## **Proposal for Supplement 6 to the 06 series of amendments to Regulation No. 16 (Safety-belt)**

The modifications to the existing text of the Regulation are marked in bold for new or strikethrough for deleted characters.

This informal document shows the amendments introduced in GRSP-56-14 as a consolidated version of the Regulation.

Figure 2  
**Installation of fixture onto vehicle seat**  
(see paragraph 2.6.1.)

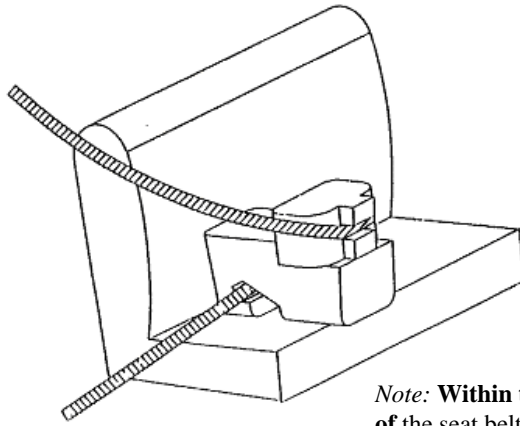
*Note: Within the adjustment range of the seat belt the webbing must shall contact, at a minimum, part of the curved edge on both sides of the fixture.*

**Figure 3**  
**Universal Booster Seat Fixture: without ISOFIX, or with anchorages removed or stowed within the body of the fixture (behind line E, as defined by detail B).**

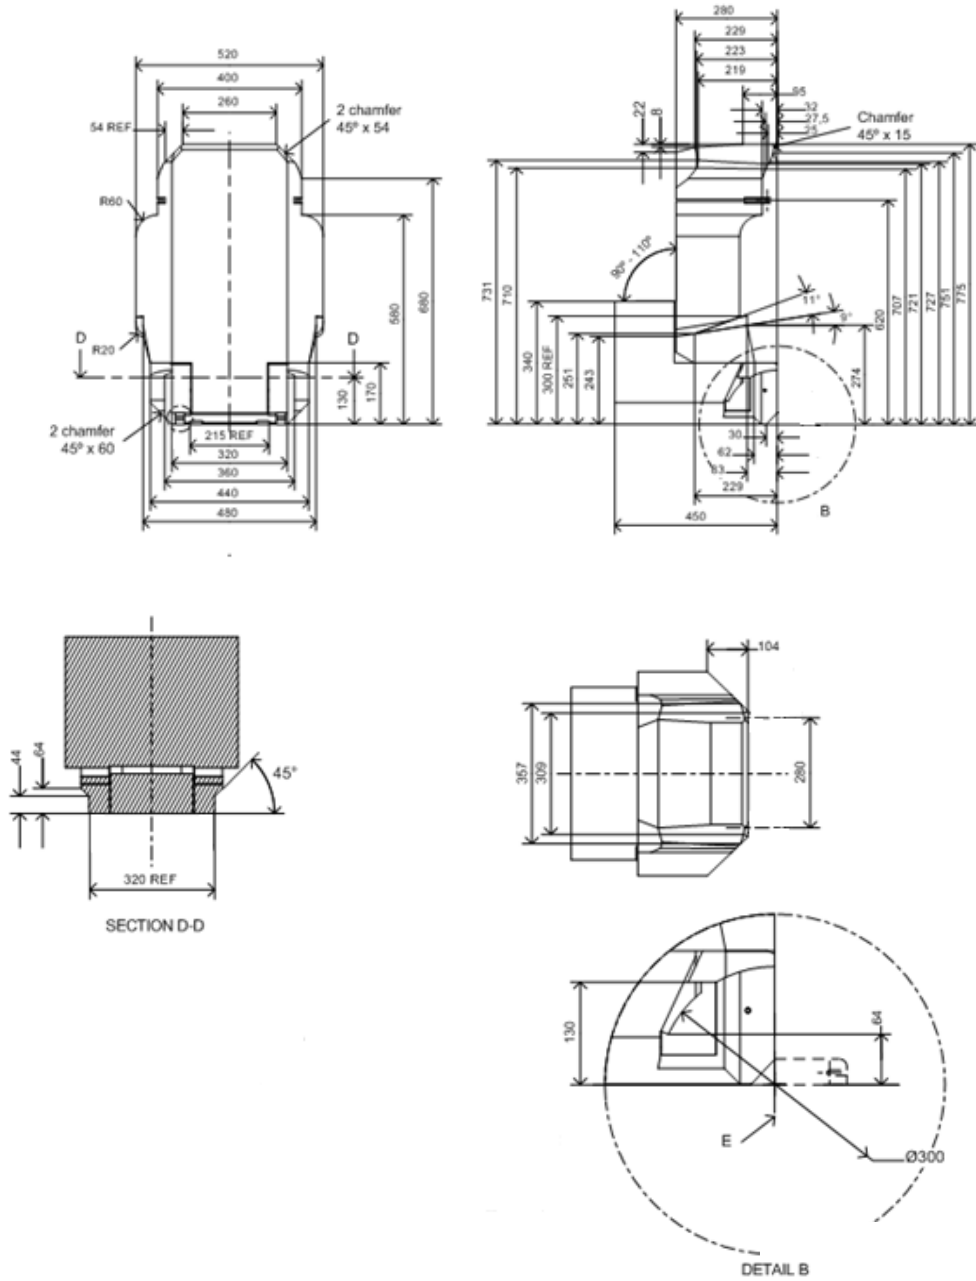
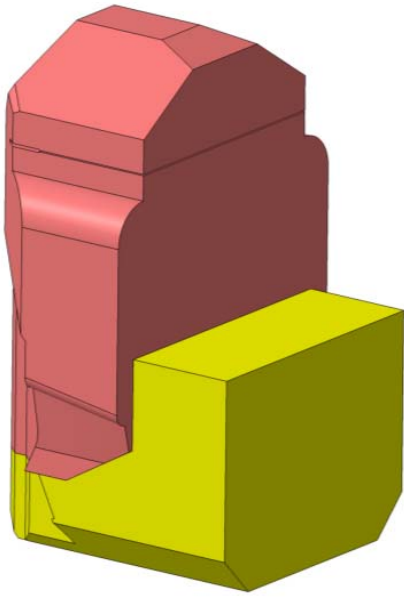
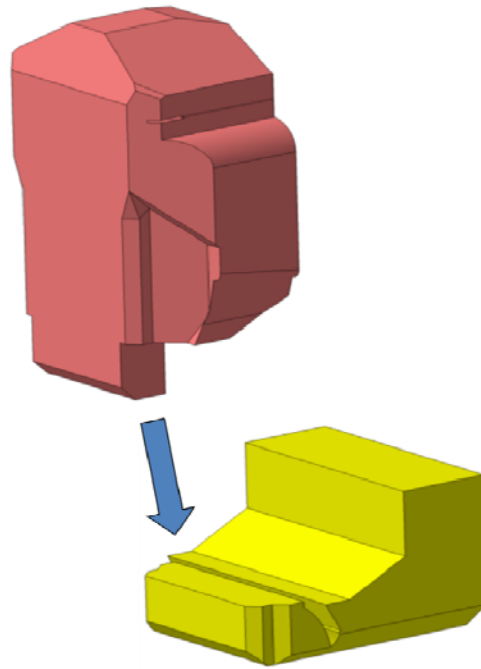
**To update:** Complete 135 cm CRF
